Agenda
Village of Arlington Heights
Design Commission
Community Room, 3rd Floor

Arlington Heights Village Hall
33 S. Arlington Heights Road
Arlington Heights, IL 60005
January 26, 2016
6:30 PM

**MINUTES OF
THE VILLAGE OF ARLINGTON HEIGHTS
DESIGN COMMISSION MEETING
HELD AT THE ARLINGTON HEIGHTS MUNICIPAL BUILDING
33 S. ARLINGTON HEIGHTS RD.
JANUARY 5, 2016**

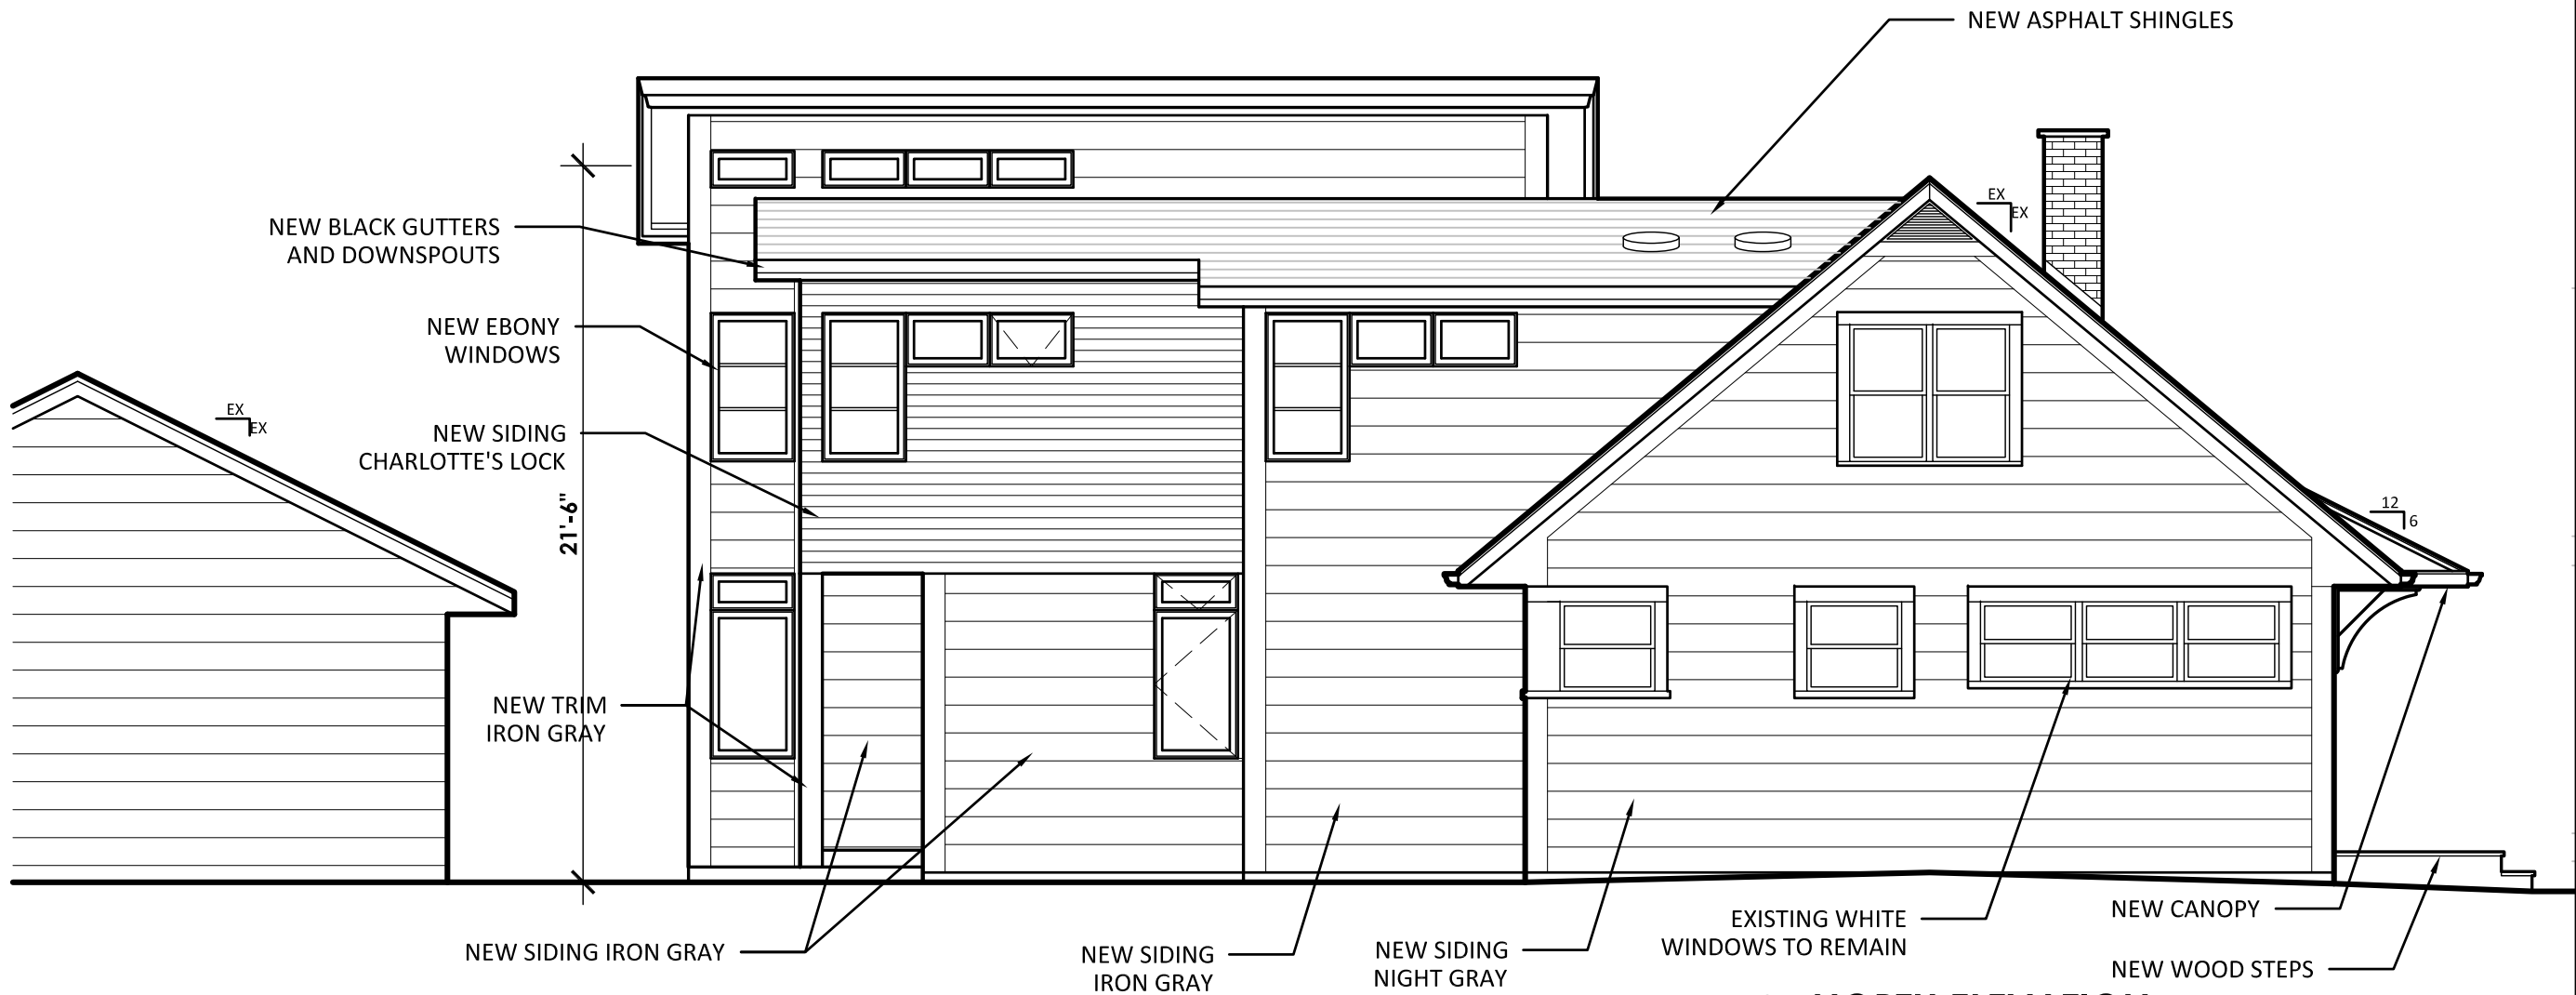
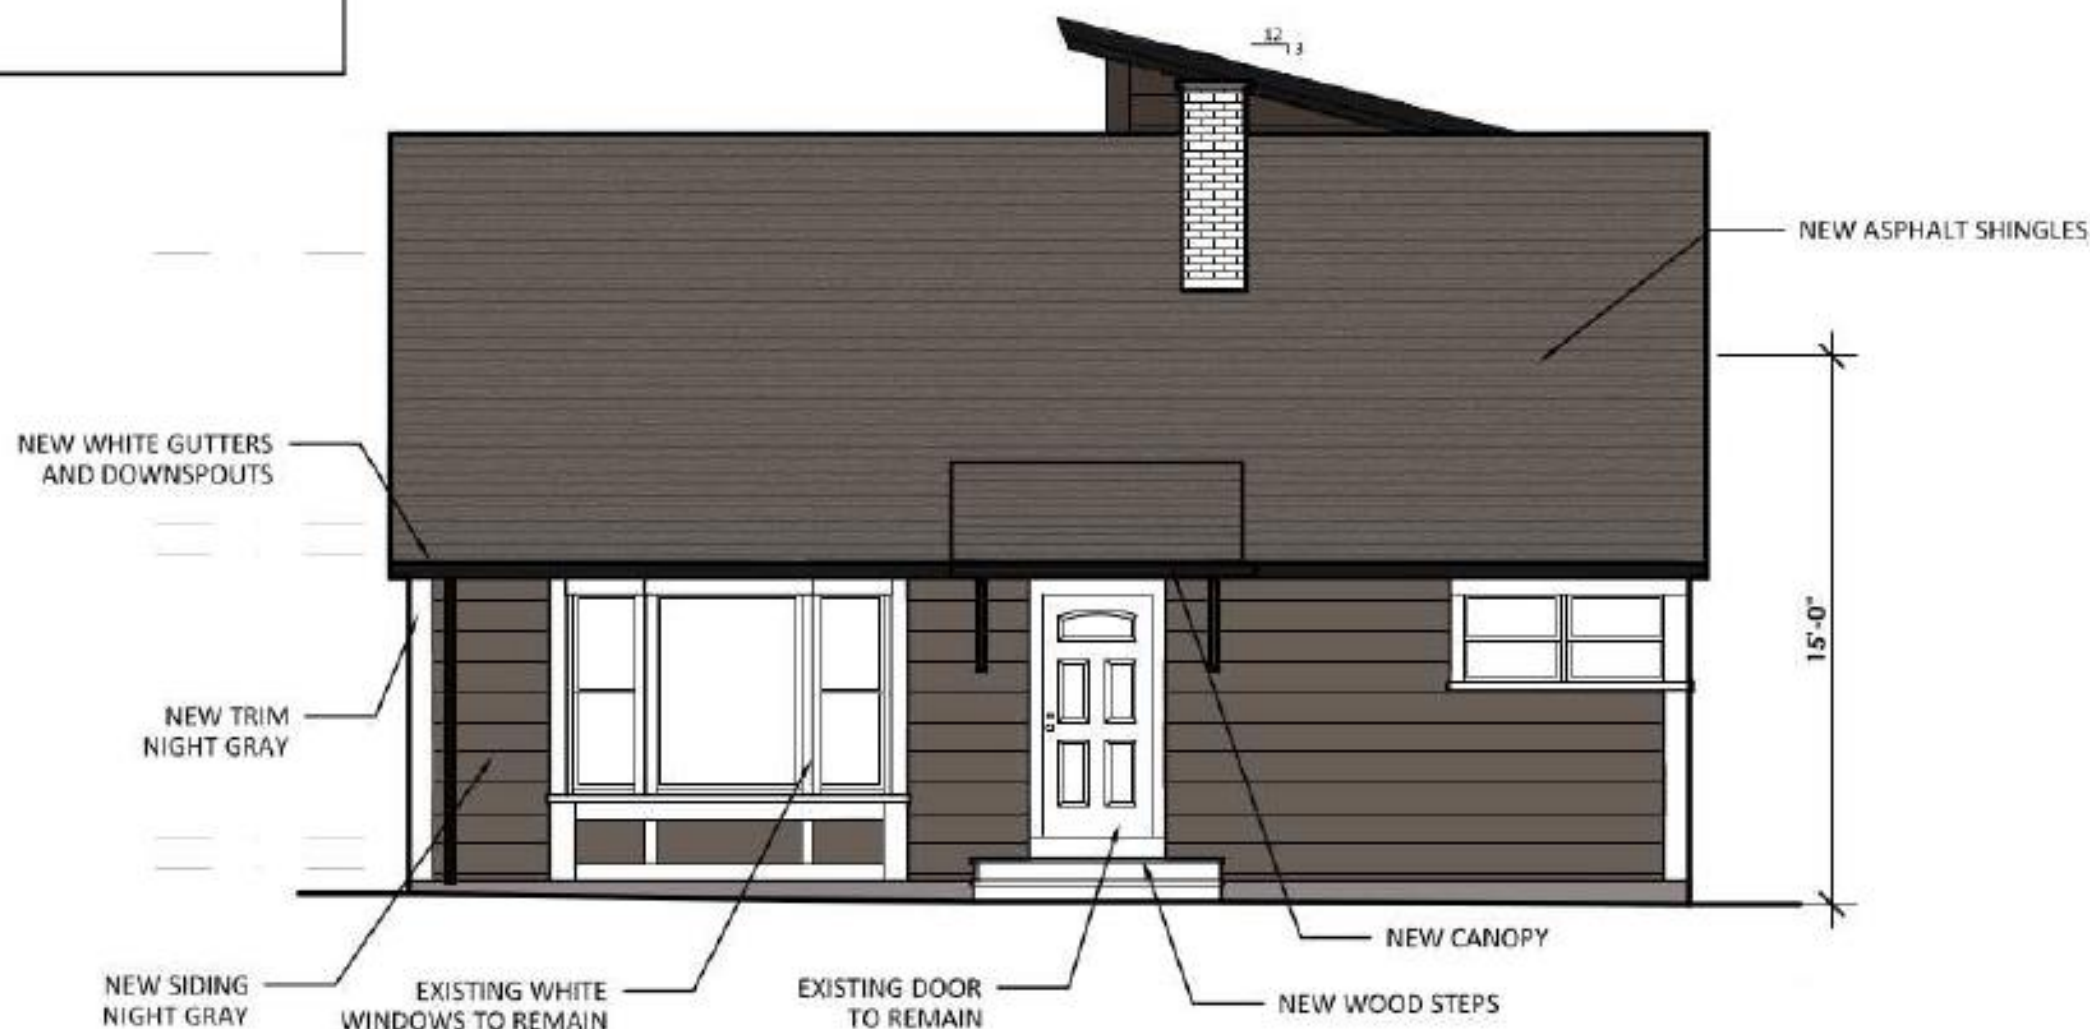
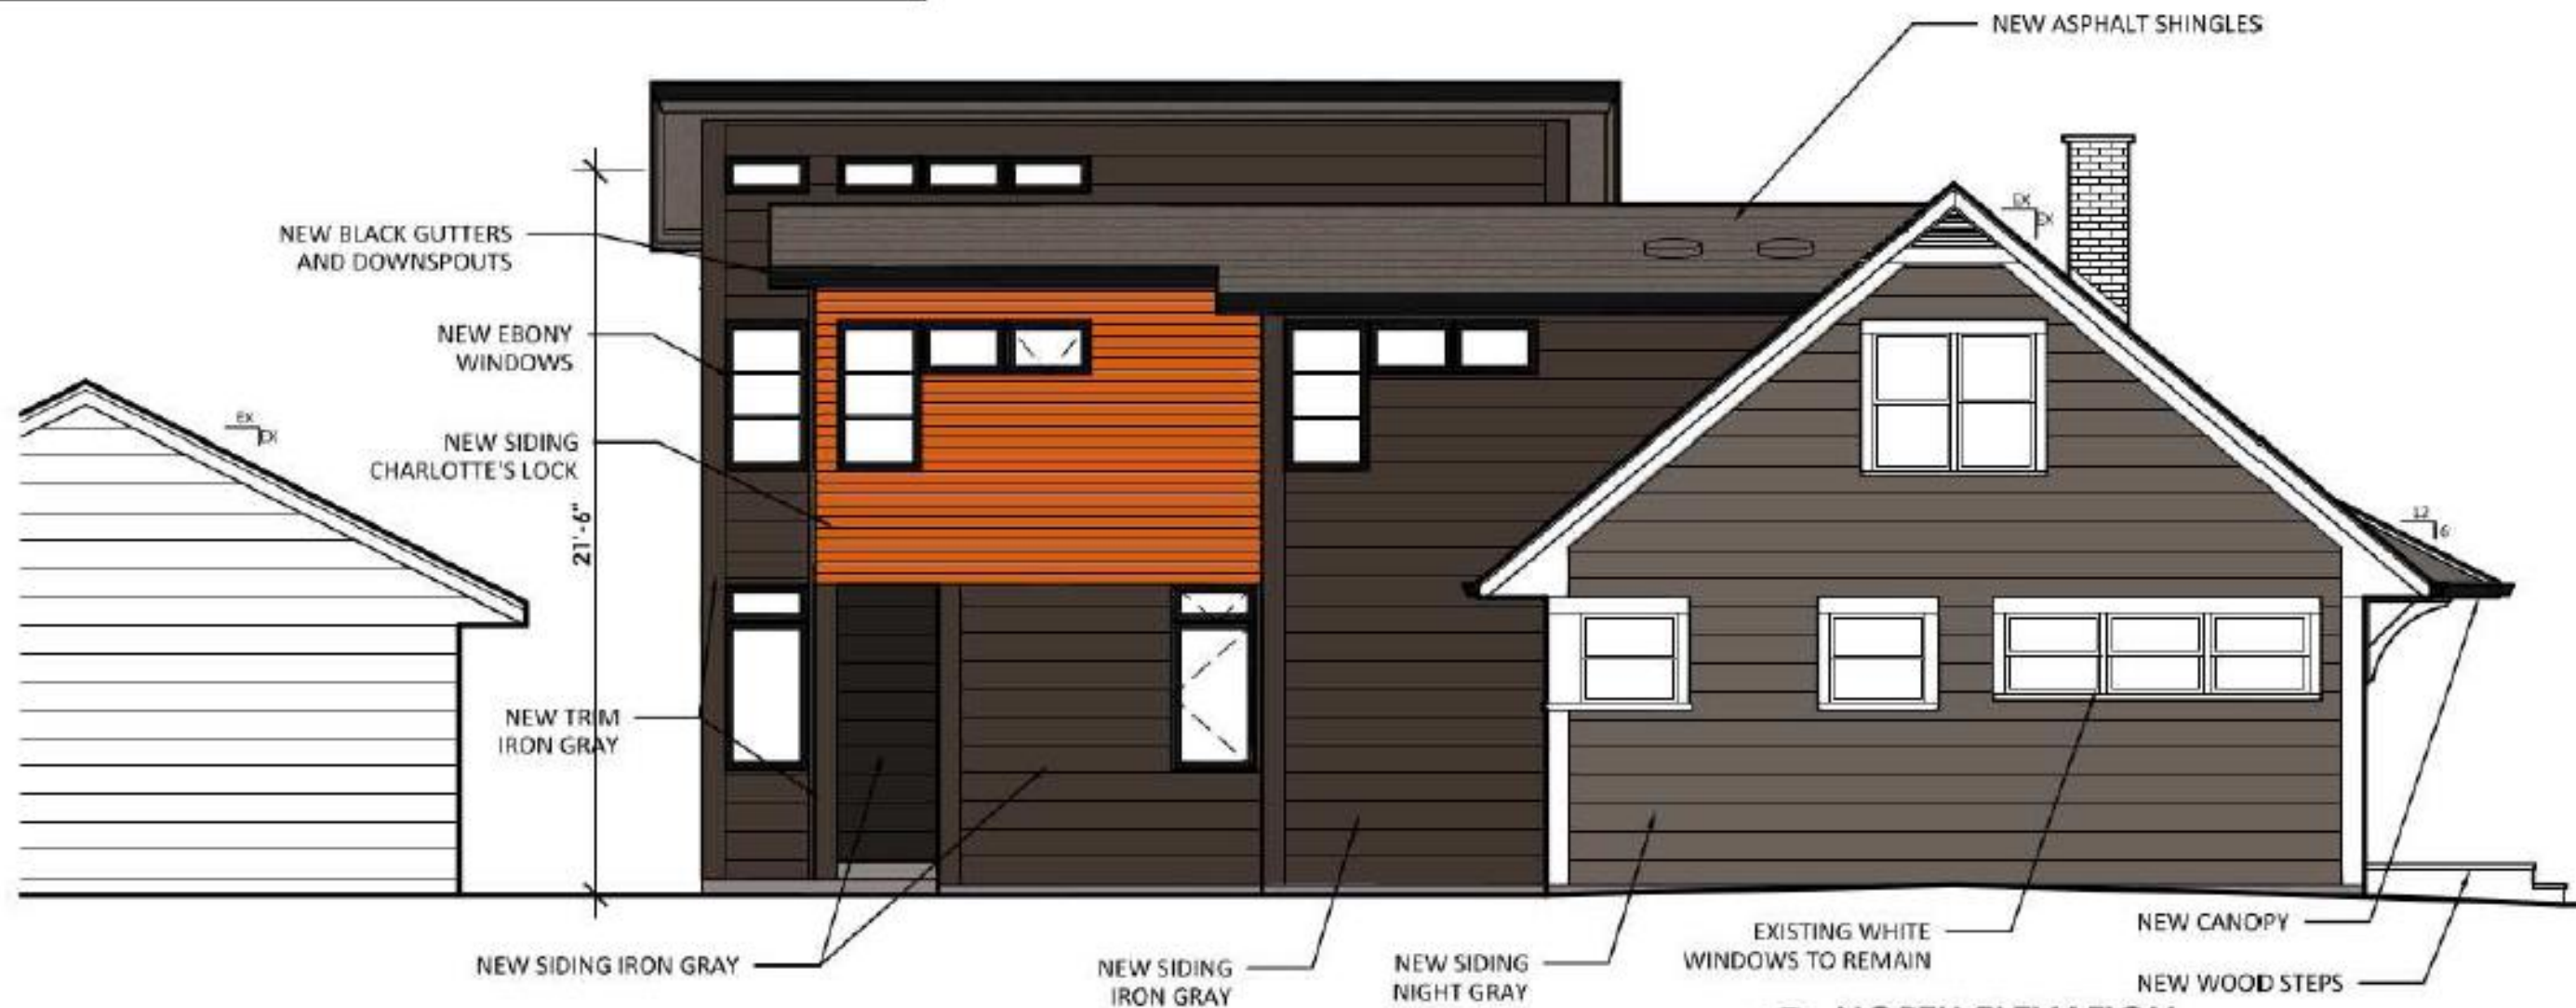
The existing neighborhood consists of a mix of traditional style single story, one-and-a-half story, and two story homes. The proposed two story addition is a modern design that is in contrast to the existing house. One of the goals of the Village's Single-Family Design Guidelines is that *"Building (additions) will reflect and improve the character of the site and the neighborhood upon which they are located. New additions will look like they belong and not dominate or change the character of the original building"*. The addition is proposed to have a bold, dark color scheme that is different than the existing part of the house, and the overall massing and form of the proposed addition does change the character of the original house.

However, the proposed addition will have very limited visibility from street, and will only be visible from the neighboring homes. The Design Commission should evaluate the appropriateness of the proposed modern style. For a more cohesive design, it is recommended that the material colors on the proposed addition be revised to match the existing portion of the house with white windows, night gray siding, white trim, and white gutters.

1. Revise the color scheme of the addition to match the house with white windows, night gray siding, white trim, and white gutters.
2. This review deals with architectural design only and should not be construed to be an approval of, or to have any other impact on, any other zoning and/or land use issues or decisions that stem from zoning, building, signage or any other reviews. In addition to the normal technical review, permit drawings will be reviewed for consistency with the Design Commission and any other Commission or Board approval conditions. It is the architect/homeowner/builder's responsibility to comply with the Design Commission approval and ensure that building permit plans comply with all zoning code, building permit and signage requirements.
3. Compliance with all applicable Federal, State, and Village codes, regulations and policies.
